**PRELIMINARY GEOTECHNICAL INVESTIGATION  
AND GEOLOGIC HAZARDS EVALUATION  
LATIGO TRAILS FILINGS 9 AND 10, 78 LOTS  
SOUTHWEST OF EASTONVILLE ROAD  
AND LATIGO BOULEVARD  
EL PASO COUNTY, COLORADO**

Project No. CS19409-115

August 3, 2021  
Revised March 31, 2022

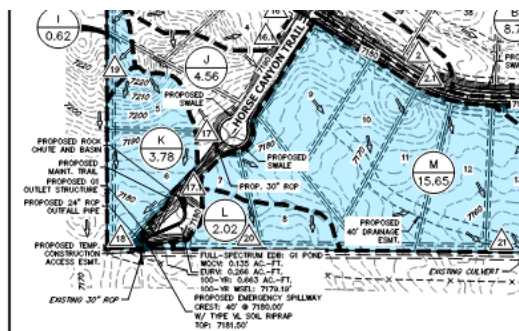
Add a section addressing the detention pond locations per the Drainage Criteria Manual Sections 11.2.2 and 11.3.3.

Unresolved. Address/provide recommendation for the proposed pond at the southwest corner of Filing 9

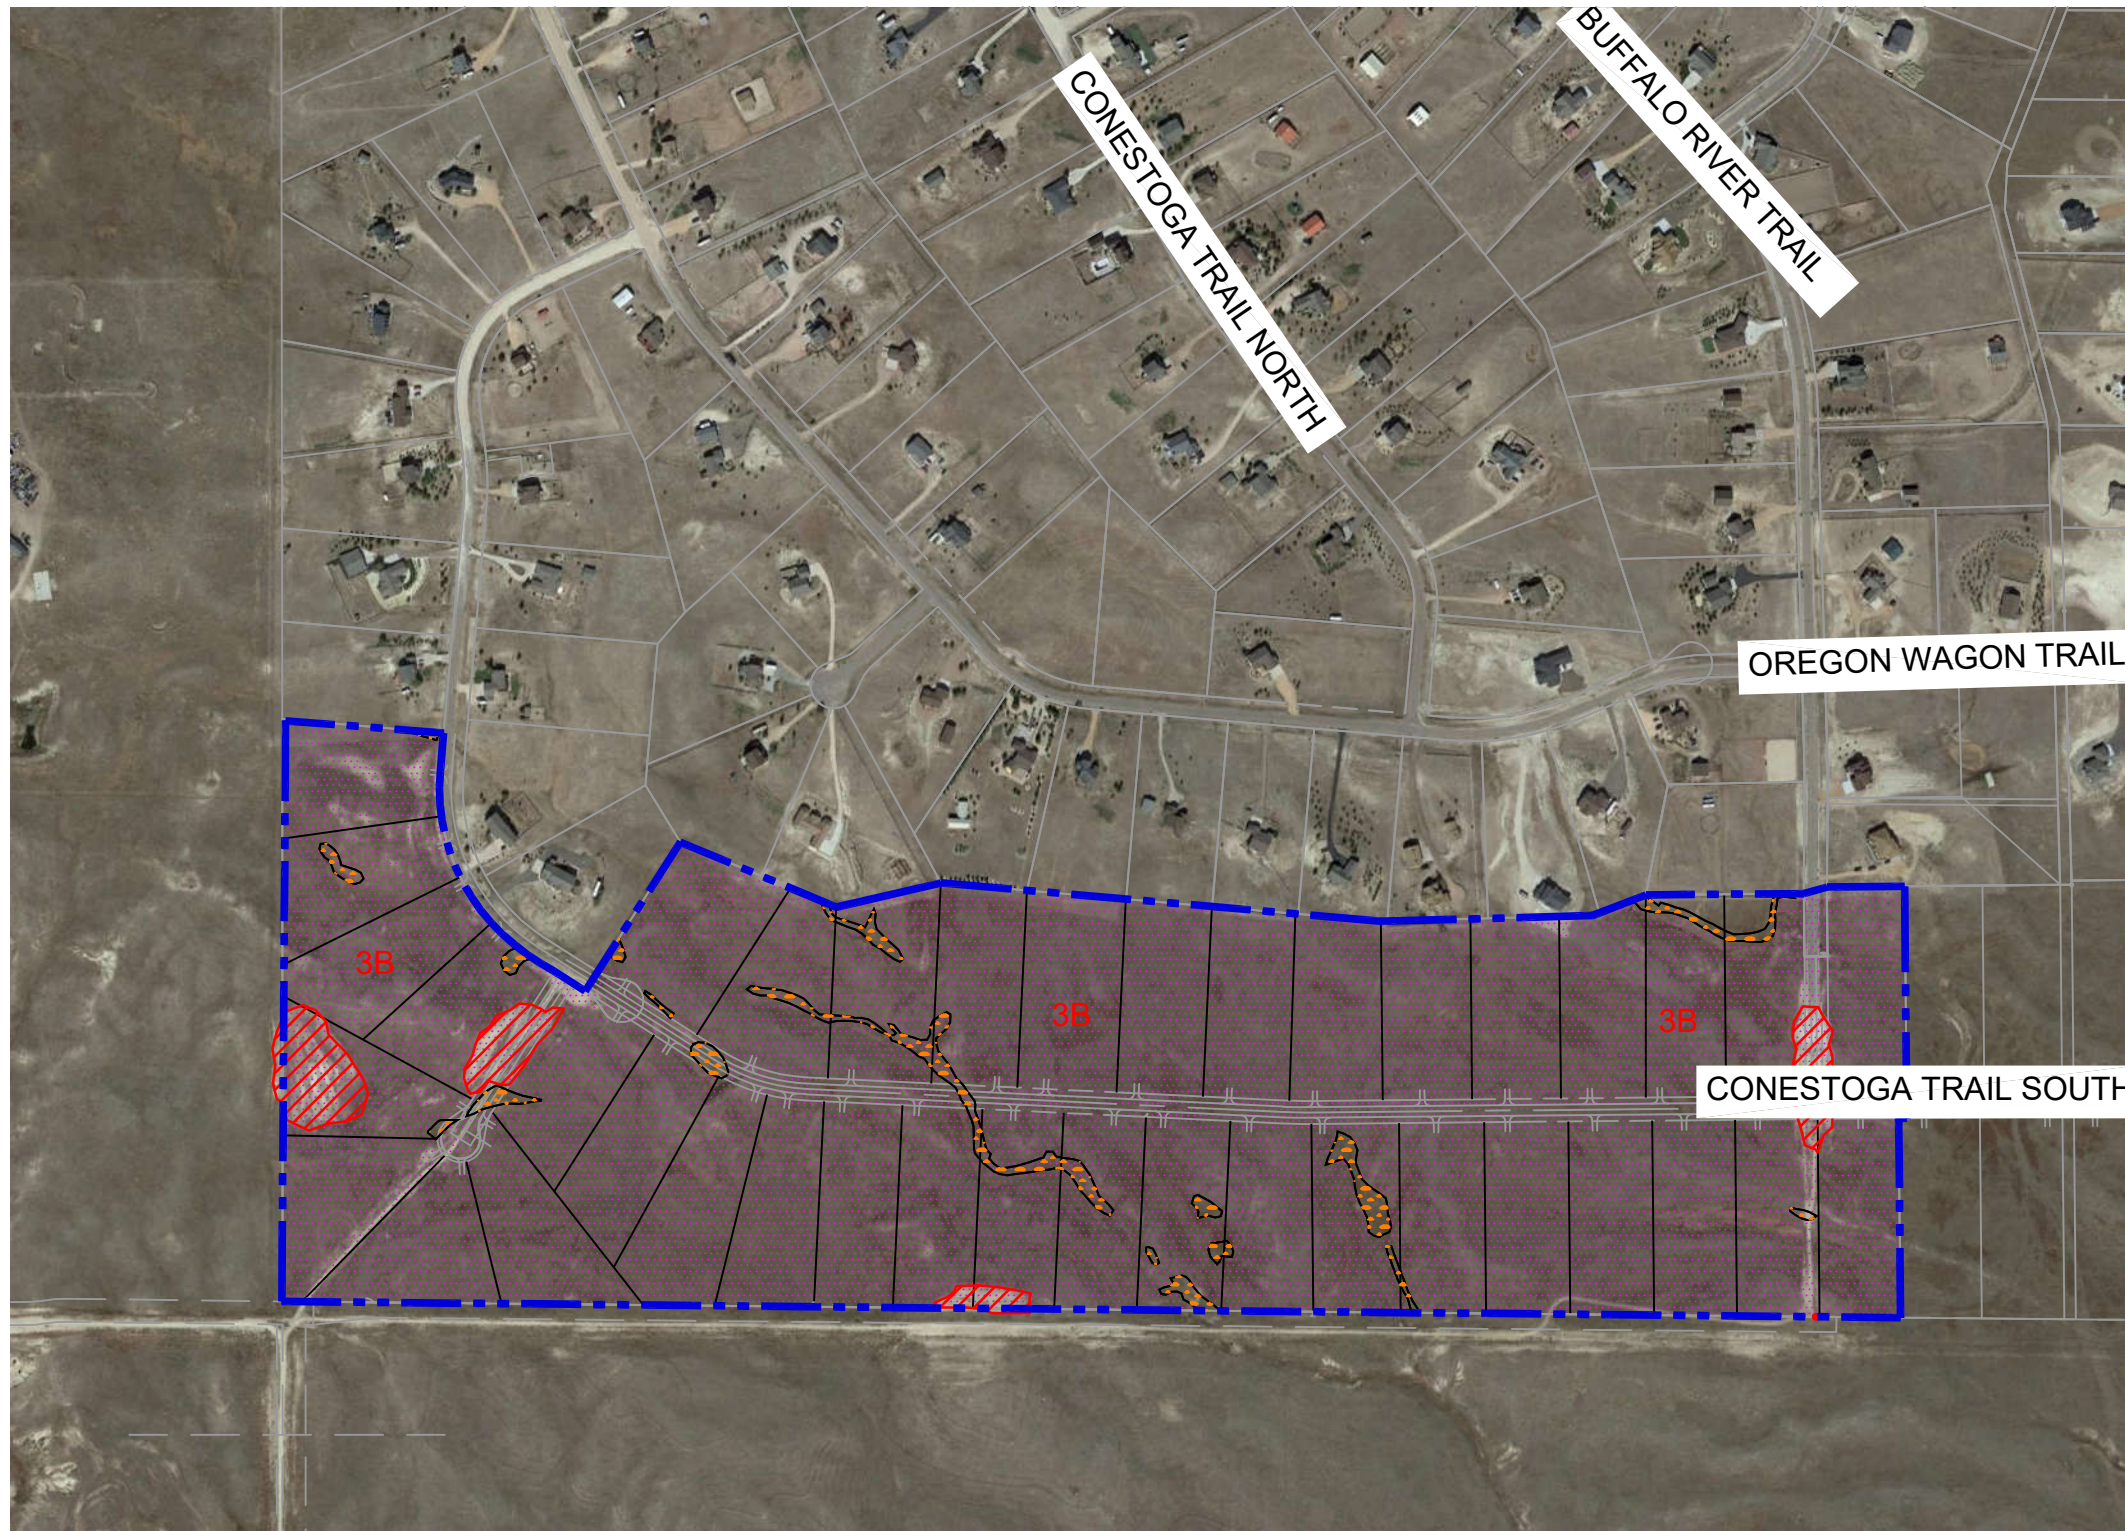
Swap Filings label
